## **3.0 DESIGN OF STRUCTURES, COMPONENTS, EQUIPMENT AND SYSTEMS**

Section 3.1 of the Levy Nuclear Plant (LNP) combined license (COL) Final Safety Analysis Report (FSAR), Revision 9, incorporates by reference Section 3.1, "Conformance with NRC General Design Criteria," of Revision 19 of the AP1000 Design Control Document (DCD). In addition, in the LNP COL FSAR, the applicant provided the following:

**Figure 3.7.1-1. Comparison of the horizontal FIRS at the elevations of -7 m (-24 ft) and +3.3 m (+11 ft) calculated by the NRC staff, the horizontal FIRS at the same elevations calculated by the applicant, and the Westinghouse CSRDS.**

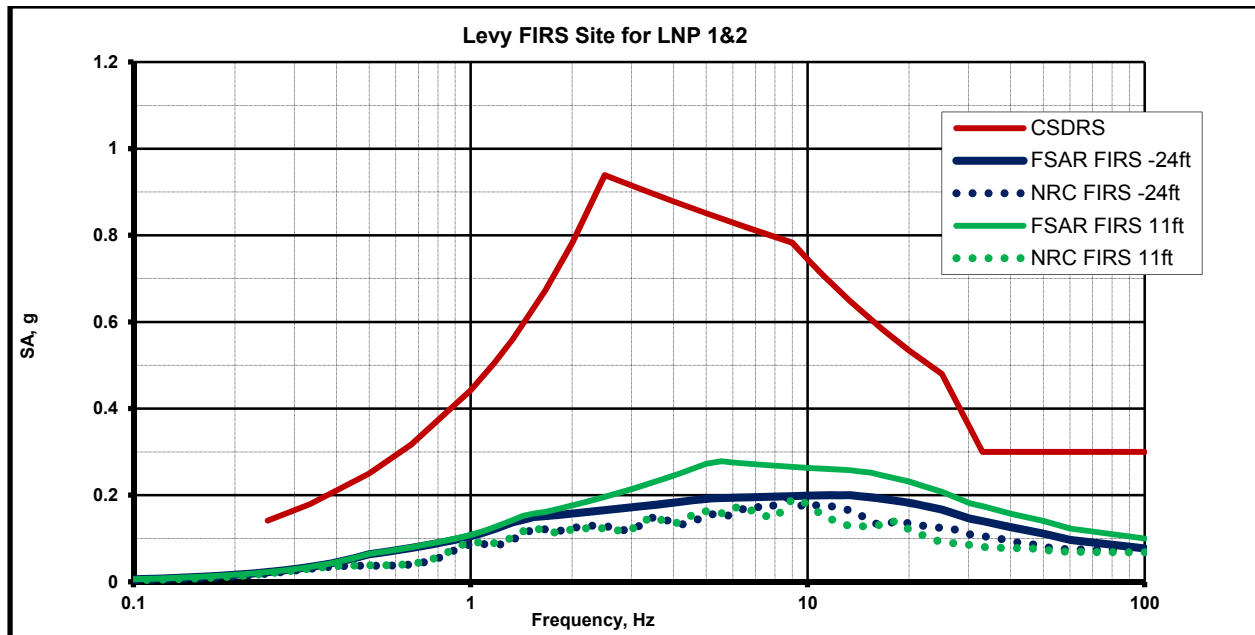
The staff performed confirmatory calculations for both FIRS using the same approach as described above for the PBSRS. For the  $V_s$  profiles for the FIRS at the elevation of -7 m (-24 ft), the staff used profiles shown in FSAR Tables 2.5.2-222 and 2.5.2-223. Modifications to these  $V_s$  profiles were made by removing the layers in the upper 15 m (50 ft). Figure 3.7.1-1 compares the staff's calculation of the FIRS with the CSDRS and FSAR (Fig.3.7-201).

The set of site amplification functions for the FIRS at the elevation of +3.3 m (+11 ft) was calculated using 10.7 m (35 ft) of concrete with  $V_s$  of 1066 m/s (3500 ft/s) (FSAR Table 2.5.4.5-201) on the top of profile used for the FIRS at the elevation of -7 m (-24 ft). Figure 3.7.1-1 compares the staff's calculation of FIRS with CSDRS and the applicant's from the LNP Unit 1 and 2 FSAR (Figure 3.7-205).

The staff's calculation of the FIRS at both elevations of -7 m (-24 ft) and +3.3 m (+11 ft) are enveloped by the applicant's FIRS and by the CSRDS. Therefore, the staff concludes that in the frequency range significant to a reactor's structures, systems, and components, there are no significant differences between the staff's and the applicant's calculated amplification functions and FIRS for the  $10^{-4}$  and  $10^{-5}$  hazard levels.
